UNITED STATES PATENT AND TRADEMARK OFFICE

10/582,122

Office Action Summary	Application No. 10/582,122	Applicant(s) BRINZ ET AL.	
	Examiner JOSHUA BENITEZ	Art Unit 2829

DETAILED ACTION

FIG. 1

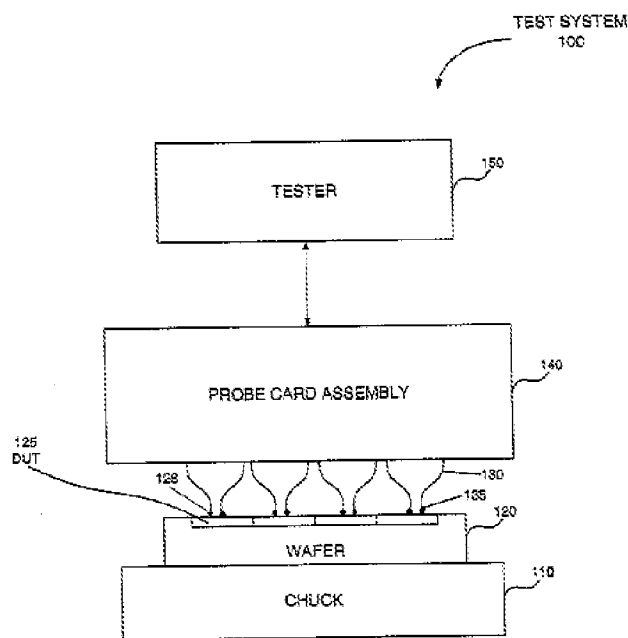
In re claim 30, Miller '567 discloses in figures 1-3A a device for analysis of at least two material samples (125) disposed on a sample plate, the device including:
a carrier (110) for the sample plate;

a contacting mechanism (130, 135, 305) for electrical contacting of the at least two material samples;

a housing carrier (140, 300 since element 300 is a modification to prior art element 140);

a measuring head (310) inserted into the housing carrier wherein the measuring head includes two measuring wires per each material sample (as shown in figure 1) for achieving electrical connection to the contacting mechanism, wherein the contacting mechanism lies against contact surfaces (126) of the sample plate with prestressing, and wherein the measuring wires are connected to a measuring and evaluation unit (150).

FIG. 3A

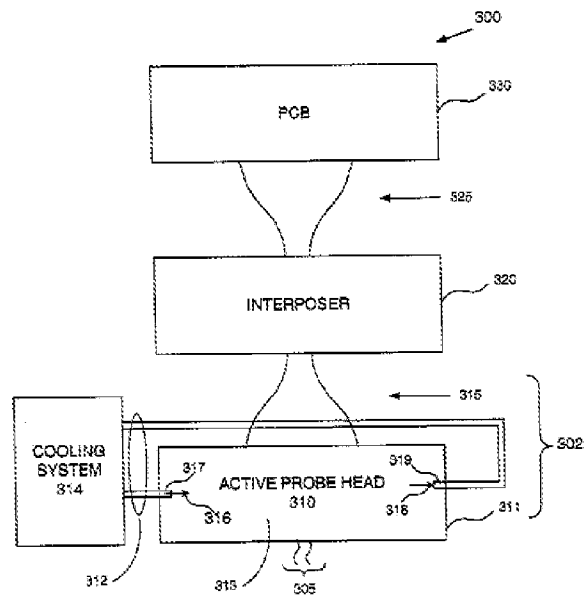
As for claim 33, Miller '567 discloses wherein the measuring head (310) is connected to a gas supply unit (314).
